Office Action Summary	Application No. 09/273,448	Applicant(s) OHKAWA, SHINGO	
	Examiner Julie-Huyen L. Ngo	Art Unit 2871

DETAILED ACTION

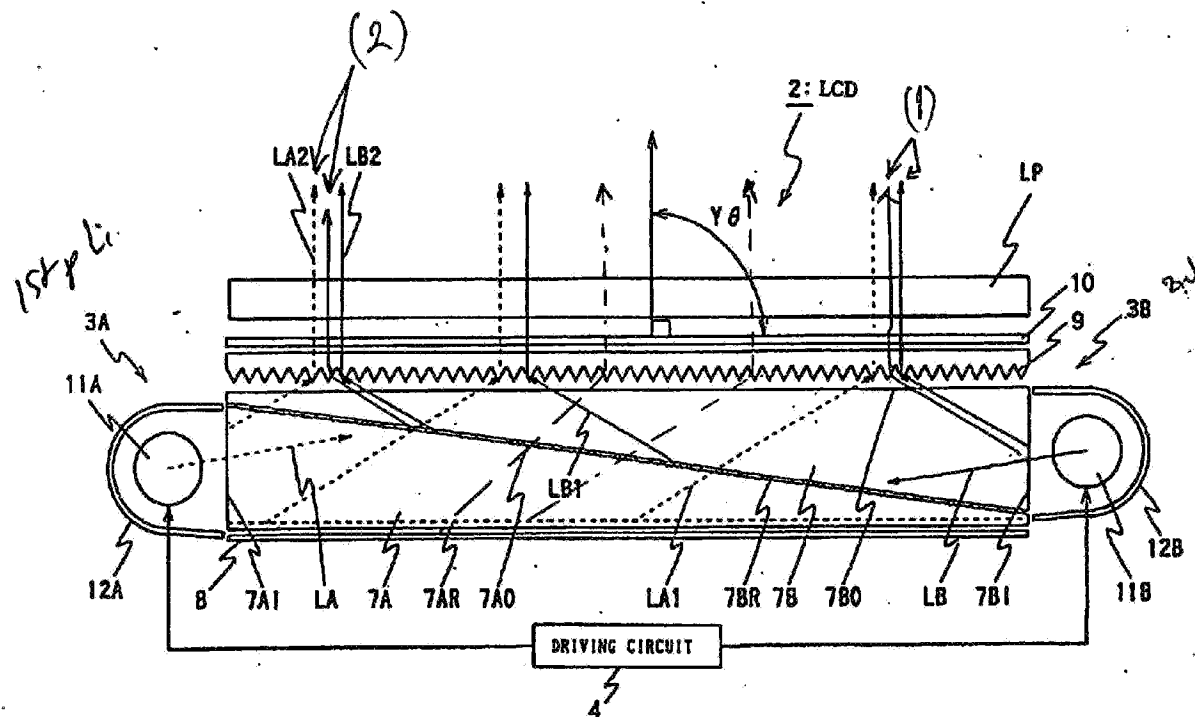
Although, Figures 2 and 6 of this application only shows that a prismatic light control member 9 provided with a great number of pairs of first and second slopes disposed along said second emission face of the second guide plate so that said first slopes only receive light from said First primary light source 11A and reflect light from said Second primary light source 11B, said second slopes receive light from said Second primary light source 11B and reflect light from said First primary light source 11A. The light rays (1) & (2), **however**, can be receivable in ALL directions (See marked up of Figure 2 below also attached to previous Office action for other possible light rays).

Furthermore, there is nothing to avoid the first and second slopes from receiving light from BOTH the First 11A and the second 11B primary light sources. The set forth above amendments to the specification regarding the function of the first and second slopes “**mainly**” receive and reflect light from the respective primary light source can not be entered and considered to be NEW MATTER added to the original disclosure.

Applicant is required to cancel the new matter in the reply to this Office Action.

F i g . 4

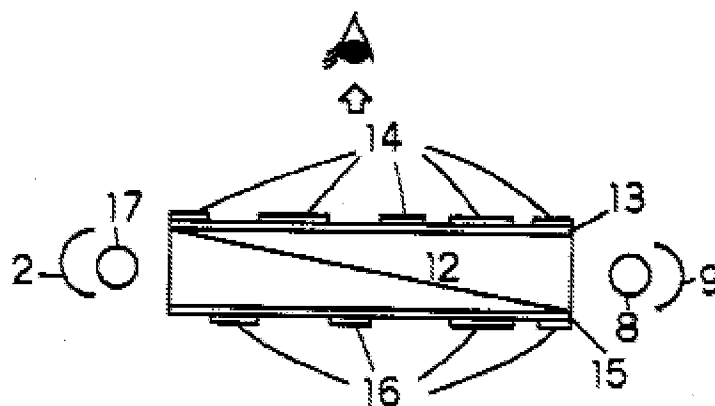
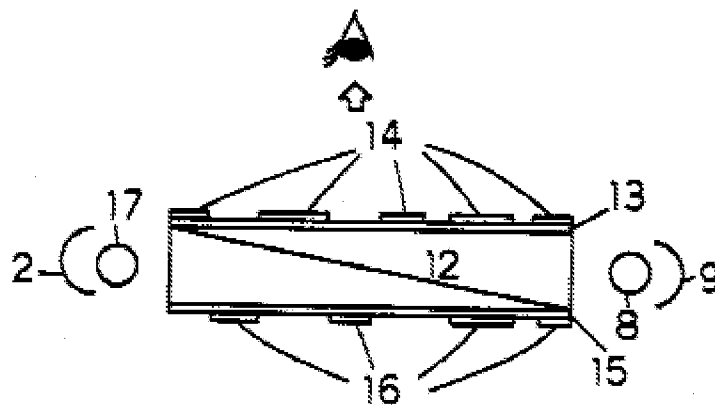
With respect to claims 13, 25 and 29 Okuda et al. teach (Fig. 4, col. 16, line 62 to col. 17, line 17) a liquid crystal display including a liquid crystal display panel and a surface light source device of side light type for backlighting of the liquid crystal display panel, said surface light source device comprising:

With respect to claims 15 and 16, Okuda et al. teach (Fig. 4) that said first and second guide plates have wedge-shaped cross sections so that said first and second incidence end faces are located at thicker ends of the cross sections, respectively.

However, Okuda et al. was used as a primary reference to show that a typical side-light arrangement having two pairs of light guide plates and 2 primary light sources 17 and 8, as shown in Fig. 4 below, to combine with the prismatic light control member (321 in figure 25 below) in Miyashita et al. device to achieve the receiving/reflecting of light as claimed for example in claims 13 and 28.

Note that once Miyashita's prismatic light control member 321 is disposed along the second emission face of Okuda's second guide plate (see figures 4 of Okuda and at least Figure 25 of Miyashita below), the First slopes would mainly received light from said first primary light source 17 and reflect light from the second/third primary light source 8; the said Second slopes would mainly received light from said second primary light source 8 and reflected light for mthe Fist primary light source 17 for improving the frontal illumination performance in Okuda surface light source device, as taught by Miyashita et al.

FIG. 23

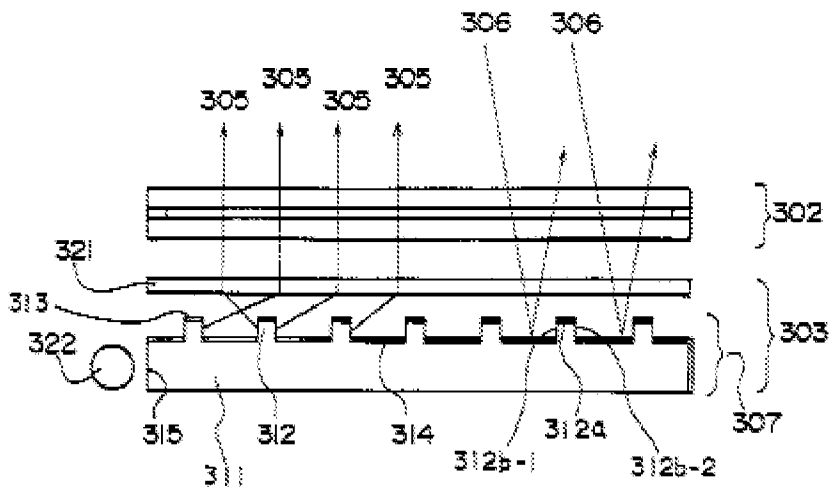
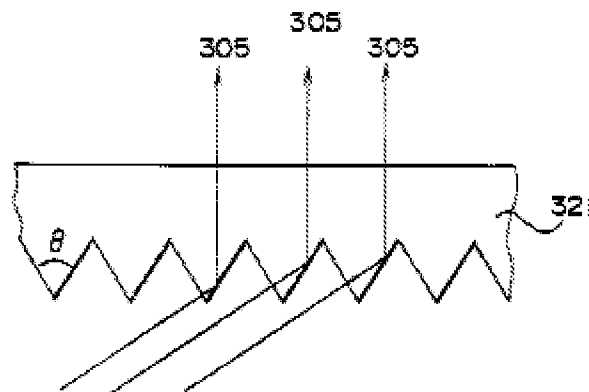
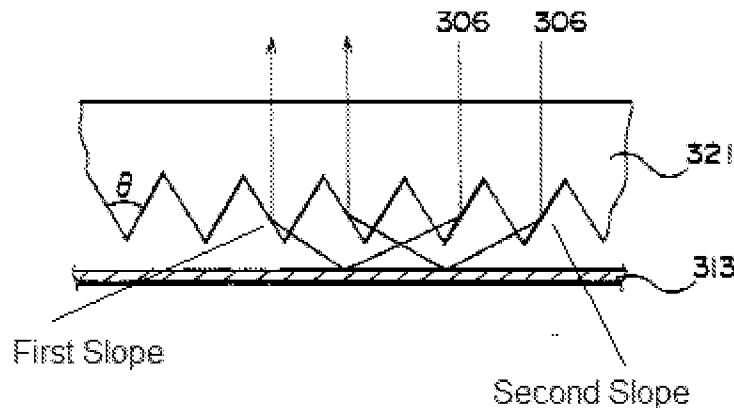
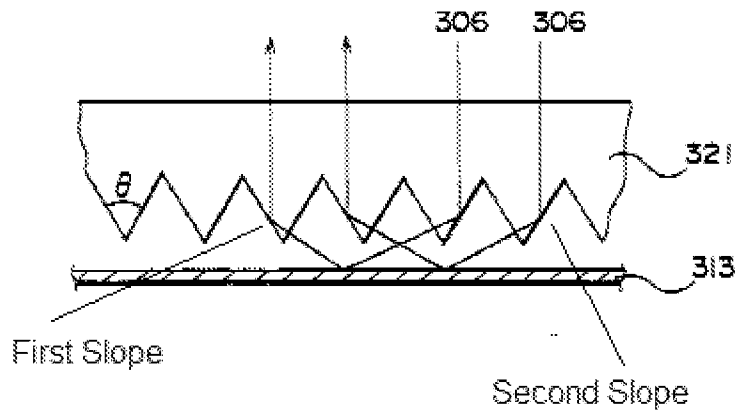
Miyashita et al. teach (at least Figs. 23-25) forming a prismatic light control member 321 with a great number of pairs of first and second slopes to control directivity of output illumination light, said prismatic light controller member is disposed along an emission face of the light guide 307. The First slopes mainly receive light from the left side of the light control member 321 or from the light source 322 and reflect light from the Right side of the light control member 321, the second slope mainly receive light from the Right side of light guide and reflect light 305 from the Left side of the light control member 321 or from the light source 322 (see figure 25 below) to control the

Therefore, it would have been obvious for one of ordinary skill in the art to modify Okuda surface light source device with Miyashita's prismatic light control member 321 having a great number of pairs of first and second slopes to control directivity of output illumination light, and to dispose said prismatic light control member along the second emission face of Okuda's second guide plate so that the first slopes mainly receive light from the first primary light source 17 and reflect light from the second/third primary light source 8; and the second slopes mainly receive light from the second primary light source 8 and reflect light from the first primary light source 17 for improving the frontal illumination performance of Okuda light source device, as taught by Miyashita et al.

Applicant's arguments filed on June 27, 2007⁸ have been fully considered; however, Miyashita et al. prismatic array/light control member (321) as shown in Figures 23 and 25 above can still meet the recitations amended in the claims 13 and 28 as set forth above.
